**JENSEN DUNES  
SECOND AMENDMENT TO  
PLANNED UNIT DEVELOPMENT ZONING AGREEMENT**

**REVISED EXHIBIT D**  
**REVISED MASTER SITE PLAN**

## Jensen Dunes PUD Residential Care Facility

**REVISED EXHIBIT D-1**  
**REVISED PHASING PLAN**

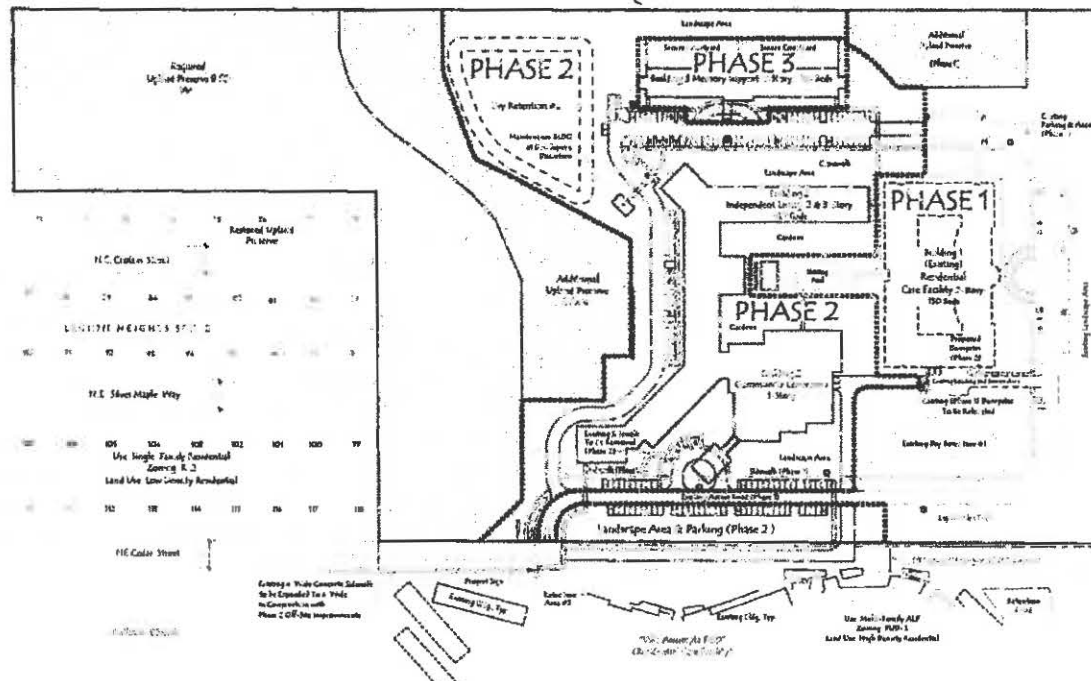
2. The Revised Master Site Plan, attached hereto and made a part hereof as Revised Exhibit D, and the Revised Phasing Plan attached hereto and made a part hereof as Revised Exhibit D-1, are amended to reflect the following changes:

- a) Deletion of the proposed extension of NE Skyline Drive from its existing location at NE South Street, through the Town of Ocean Breeze, to the project's entrance;
- b) Addition of a "permanent" secondary vehicular and pedestrian access connection to NE Cedar Street;
- c) Extension of the existing 6' sidewalk at the project's entrance east, along the project's entire frontage on NE Cedar Street;
- d) Addition of additional parking and a continuous loop road around the project's development area;
- e) Deletion of the optional picnic area and trail within the upland preserve area;
- f) Reconfiguration of Building #3 from a 2-story building with 130 beds to a one-story building with 50 beds; and
- g) Reconfiguration of Building #2 from a 2-story building with 130 beds to a three-story building with 160 beds and an attached one-story Community Commons building.

**Phase 1:**  
Construction of Building 1 (up to 130 beds), supporting drainage, utility and infrastructure improvements including permanent primary access to NE Cedar Street, dry retention area #1, water main extension to fire hydrant #1, sanitary sewer service, cleanout, manhole #1, private lift station and force main, parking, recreation facilities, landscape improvements and all PAMP requirements

**Phase 2:**  
Construction of Building 2 (up to 160 beds), supporting drainage, utility and infrastructure improvements including permanent secondary access to NE Cedar Street, dry retention areas #2 and #3, extension of 8' sidewalk along the project's entire frontage on NE Cedar Street public right-of-way, parking, landscape improvements and elements of the NE Cedar Street Improvement Plan pursuant to revised Special Condition #12, 2nd PUD Amendment.

**Phase 3:**  
Construction of Building 3 (up to 50 beds) including supporting drainage, utility, landscape and infrastructure improvements

**NE CEDAR STREET IMPROVEMENT PLAN**

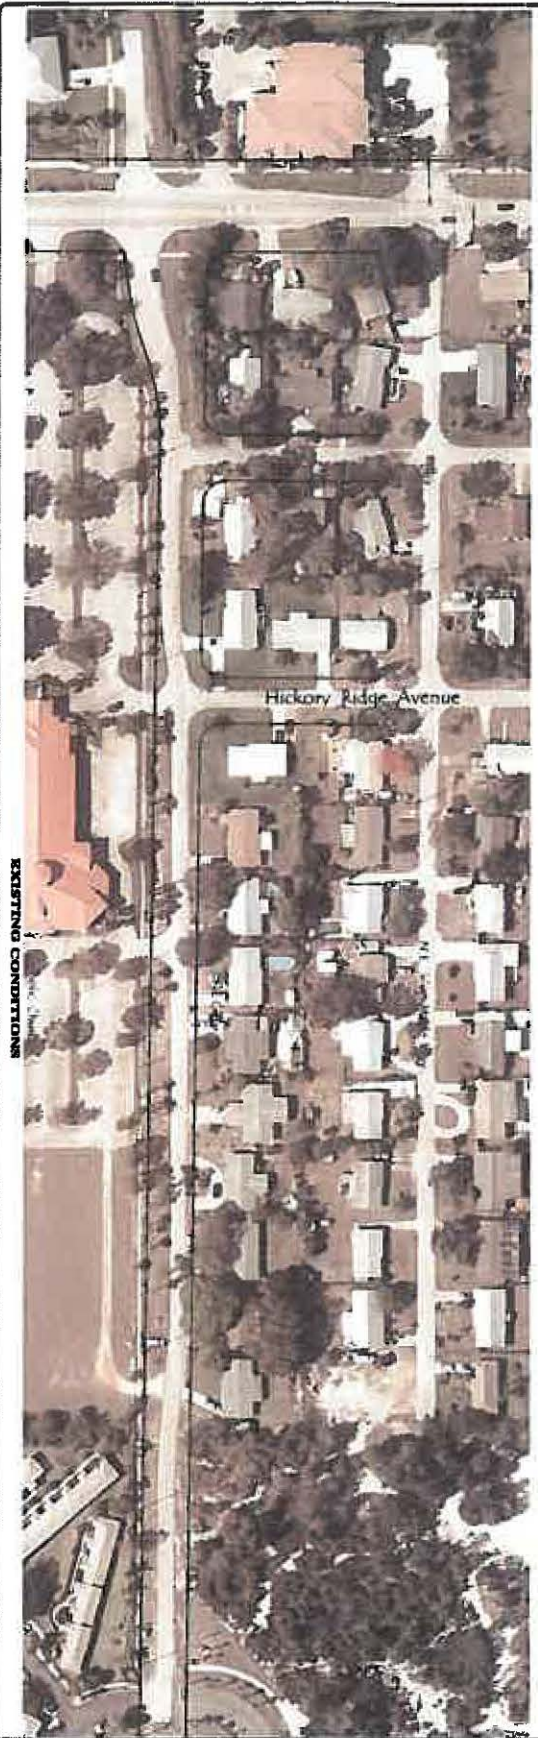
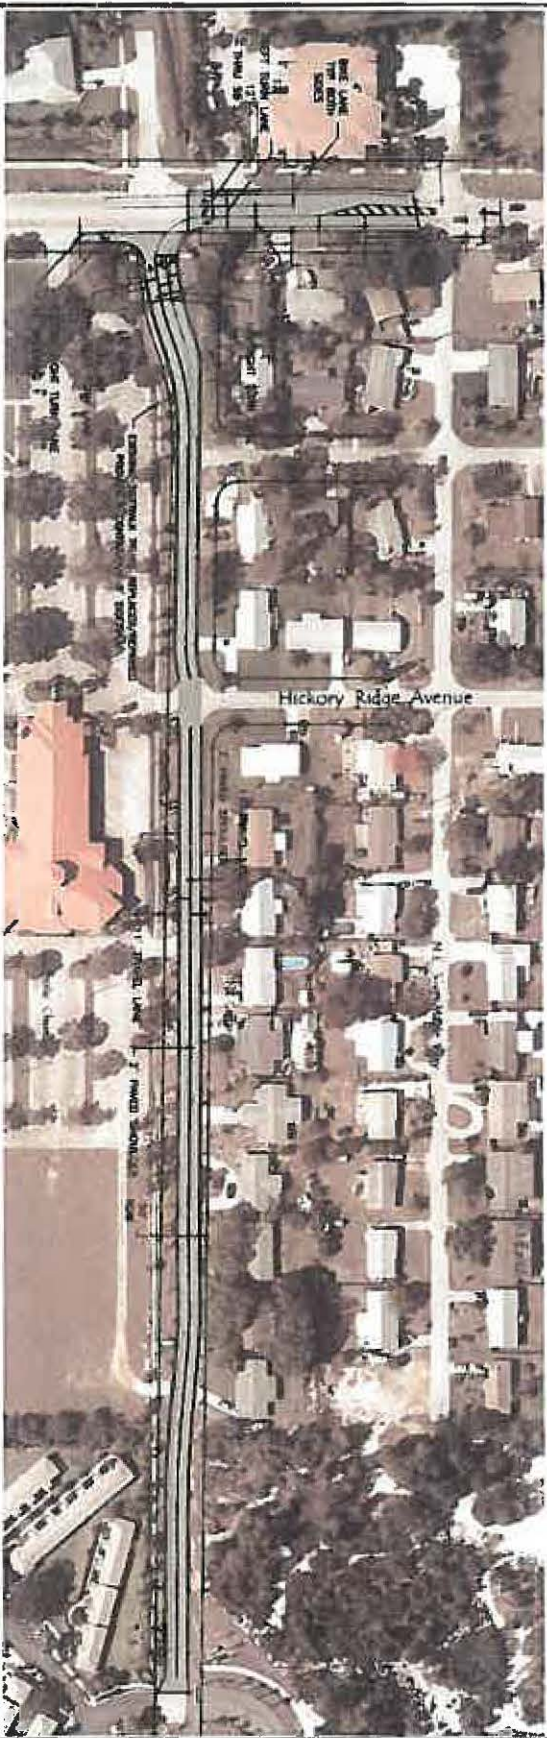
ii. All intersection, roadway and sidewalk improvements as shown on the NE Cedar Street Improvement Plan attached hereto and made a part hereof as Exhibit "D-2";
